# PARTS & SERVICE NEWS

REF NO.	AT99198
DATE	Jan. 6, 2000

**SUBJECT:** REPAIR OF POWER TILT BUSHING ON GD825A-2

**PURPOSE:** To introduce modification procedures for bushings in the power tilting mechanism on GD825A-2 motor graders (undergone the work equipment minor change)

(Fig. 13)

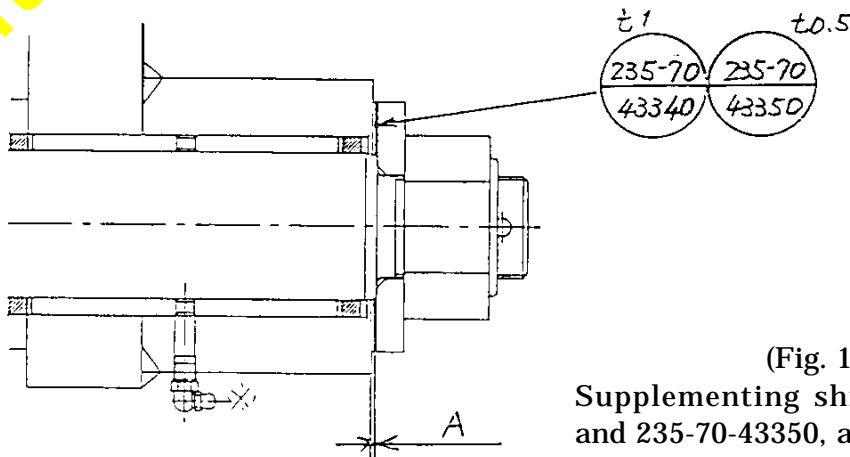
Supplementing shims 235-70-43340 and 235-70-43350, adjust the clearance "A" to 0.5 mm or less.
